Proposal for amendment of ECE/TRANS.WP.29/GRE/2009/56

The modifications to current text of ECE/TRANS.WP.29/GRE/2009/56 amendment of Regulation No. 123 are marked in bold.

Table 7: Requirements concerning the gradual adaptation of the main-beam according to paragraph 6.3.6 of this Regulation.

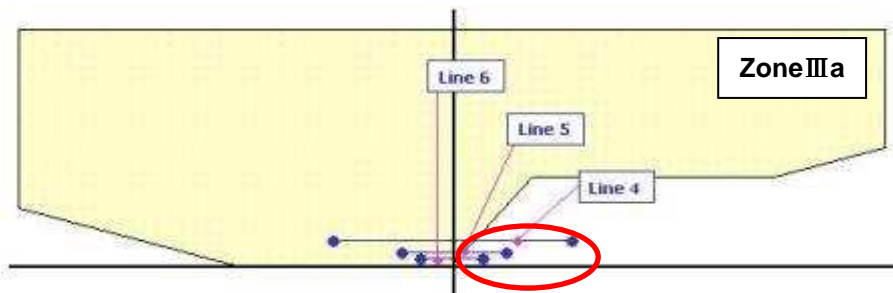
Part A of Table 7 is intended to ensure that when the adaptive driving beam is operated discomfort (glare) to the oncoming and preceding drivers is avoided.

Regarding the glare requirement, Zone IIIa has already specified in the ECE R123 as the one of dipped beam photometric requirement. However, Line 4, 5, and 6 proposed by GTB impose the additional requirement for the area, which does not specify anything as the dipped beam photometric requirement.

This means that there is an inconsistency between the existing dipped beam photometric requirement and adaptive driving beam photometric requirement.

We, Japan proposes the change of the horizontal position of Line 4, 5 and 6 based on the boundary of Zone IIIa as shown in the below. And also, we propose the deletion of one of the sentences in the table 7.

Annex 3, Table 7, amend the table:

Part A	Test Point	Position / deg. */		Max. Intensity **/	
		Horizontal	Vertical	(cd)	(lx)
	Line 1 Oncoming vehicle at 50m	4.8°L to 2°L	0.57°Up	440	0.7
	Line 2 Oncoming vehicle at 100m	2.4°L to 1°L	0,3°Up	1300	2.0
	Line 3 Oncoming vehicle at 200m	1.2°L to 0.5°L	0,15°Up	3800	6.0
	Line 4 Preceding vehicle at 50m	1.7°L to 1.7°R-0.3°R	0,3°Up	1320	2.1
	Line 5 Preceding vehicle at 100m	0.9°L to 0.9°R 0.14°R	0,14°Up	3900	6.2
	Line 6 Preceding vehicle at 200m	0.45°L to 0.45°R 0.1°R	0.1°Up	11400	18
